Source: CT3
Title: CRs to Rel-5 (and mirror) to Work Item SCUDIF
Agenda item: 8.7
Document for: APPROVAL

Tdoc # C3-050389
Revision of C3-050280

Title:	# Correction to figure 4.3.5.2/1, wrong Bearer Capability in MODIFY REJECT-message		
Source:	# Nokia		
Work item code:	# SCUDIF	Date:	# 25/04/2005
Category:	# F	Release:	# Rel-5
	<i>Use one of the following categories:</i> F (correction) A (corresponds to a correction in an earlier release) B (addition of feature), C (functional modification of feature) D (editorial modification) Detailed explanations of the above categories can be found in 3GPP TR 21.900 .		<i>Use one of the following releases:</i> Ph2 (GSM Phase 2) R96 (Release 1996) R97 (Release 1997) R98 (Release 1998) R99 (Release 1999) Rel-4 (Release 4) Rel-5 (Release 5) Rel-6 (Release 6) Rel-7 (Release 7)

Tdoc # C3-050390
Revision of C3-050281

Figure 4.3.5.2/1:Service Change Rejected

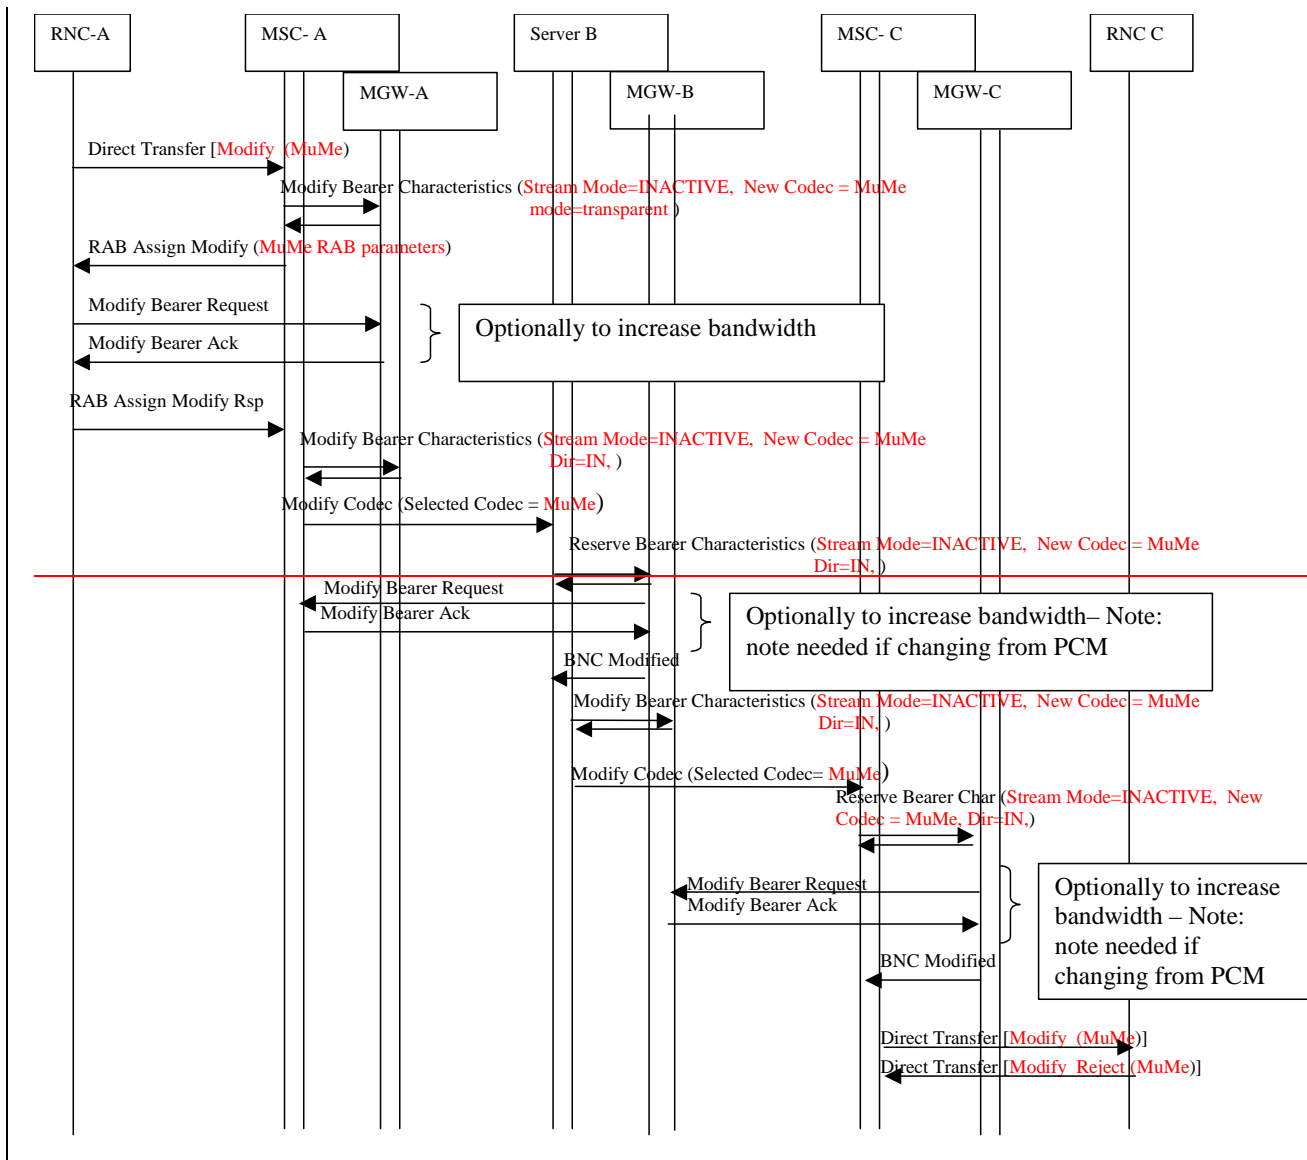
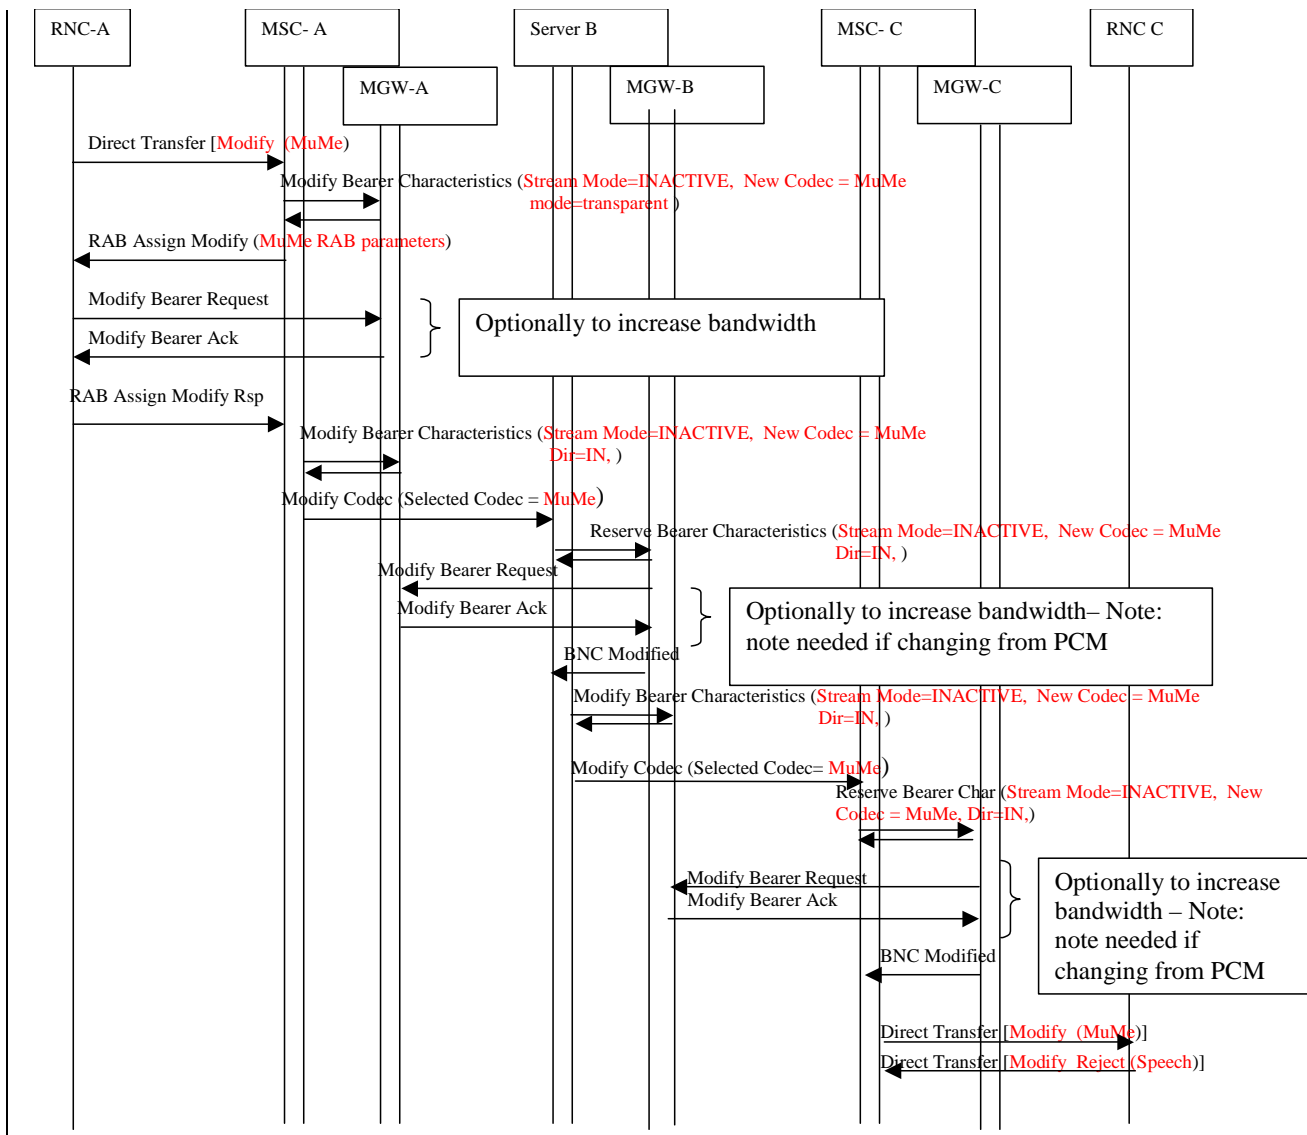
Reason for change:	# in TS 24.008 v. 5.12.0 in section 5.3.4.3.4.2 is stated: If the mobile station cannot support the change to the requested call mode, the mobile station shall: release any resources which had been reserved for the alternation; send a MODIFY REJECT message with the old bearer capability and cause # 58 "bearer capability not presently available", and enter the "active" state. InTS 23.172 in figure 4.3.5.2/1 the Modify Reject-message has the bearer capability for MuMe although it should be for speech. Modify Bearer Request and Modify Bearer Acknowledge messages are shown in figure 4.3.5.2/1 to be sent between MSC-A and MGW-B, but the correct elements would be MGW-A and MGW-B.
Summary of change:	# The Bearer Capability in the Modify Reject-message is corrected to be speech instead of MuMe. The Modify Bearer Request/Ack messages are corrected to be sent between MGW-A and MGW-B.

Figure 4.3.5.2/1: Service Change Rejected

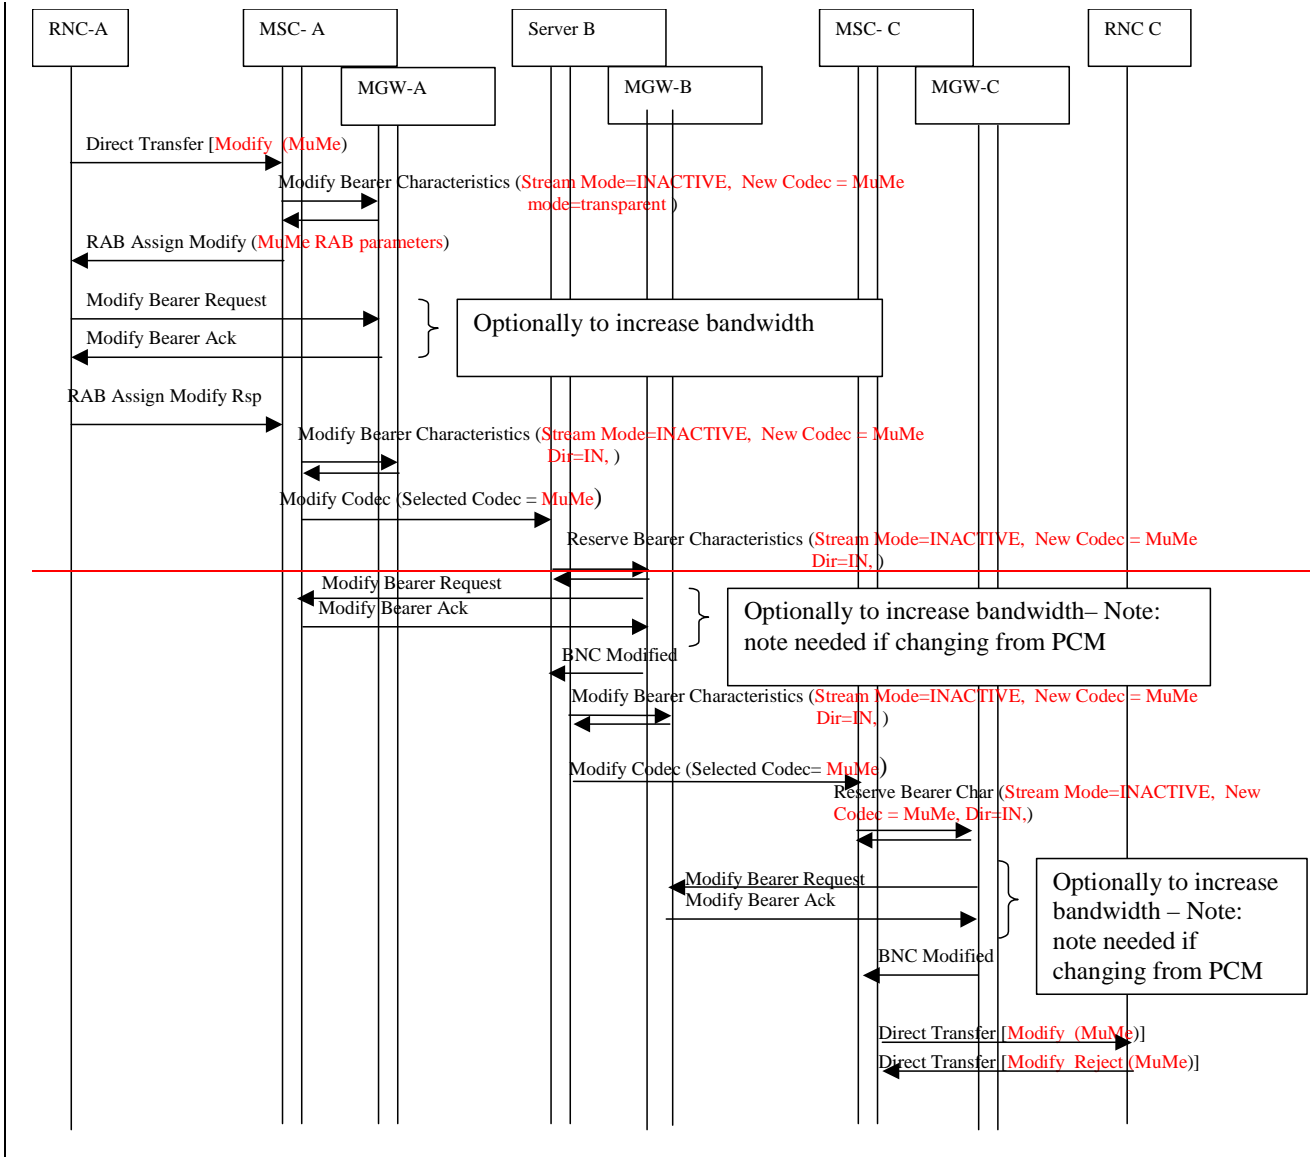
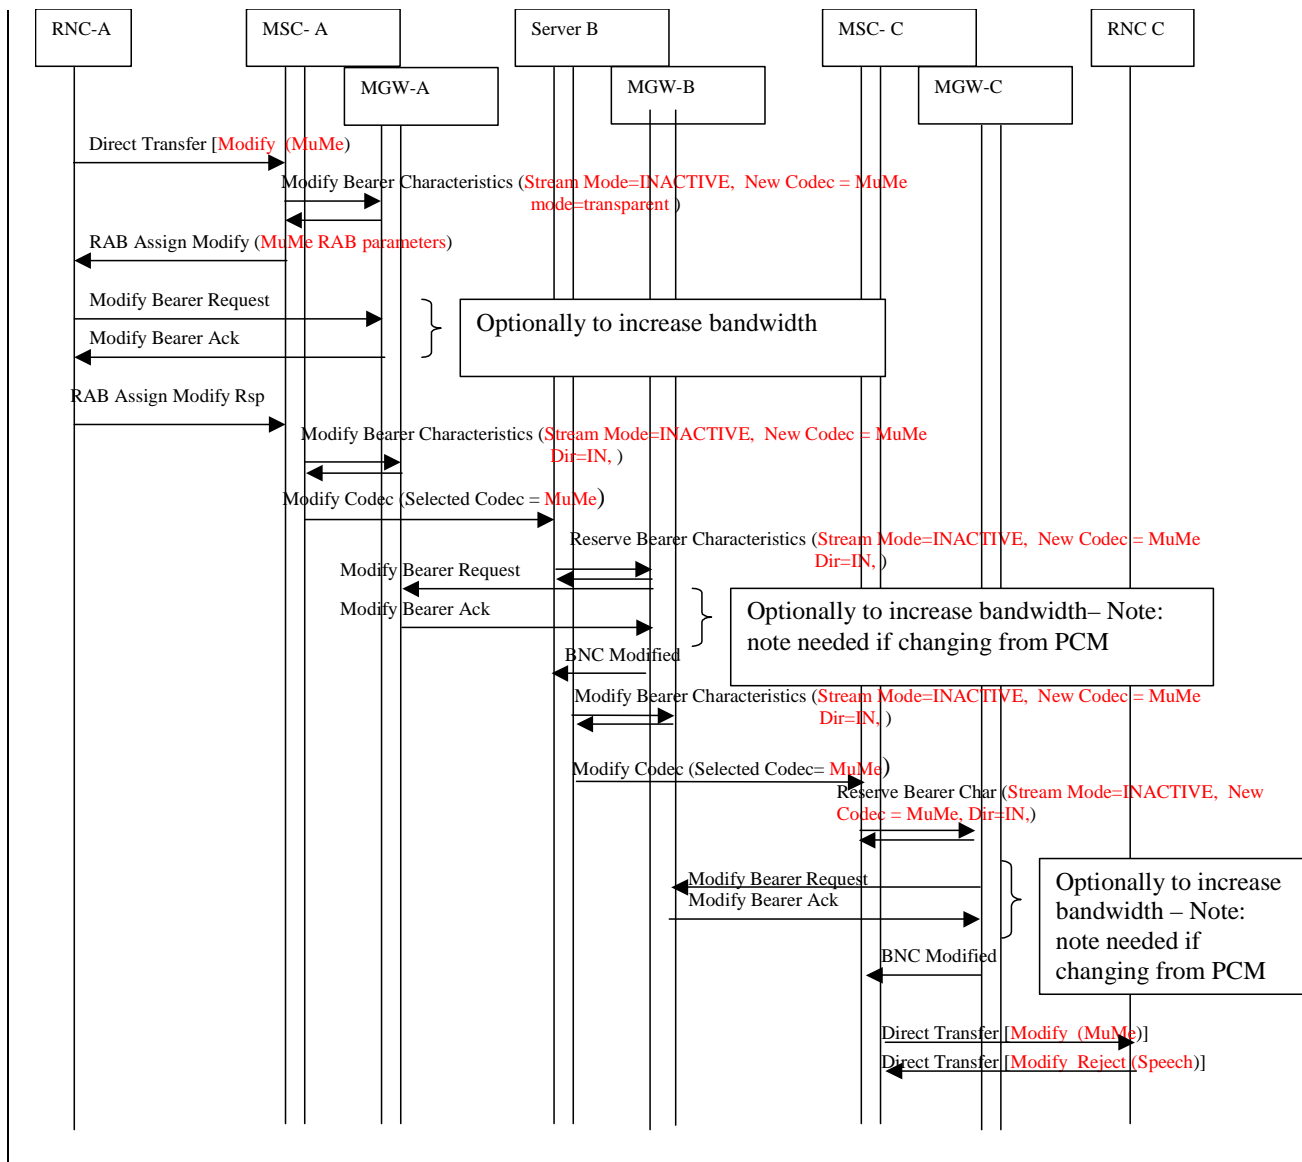
In TS 23.172 in figure 4.3.5.2/1 the Modify Reject-message has the bearer capability for MuMe although it should be for speech.
[Modify Bearer Request and Modify Bearer Acknowledge messages are shown in figure 4.3.5.2/1 to be sent between MSC-A and MGW-B, but the correct elements would be MGW-A and MGW-B.](#)

Summary of change: ⌘ The Bearer Capability in the Modify Reject-message is corrected to be speech instead of MuMe. [The Modify Bearer Request/Ack messages are corrected to be sent between MGW-A and MGW-B.](#)
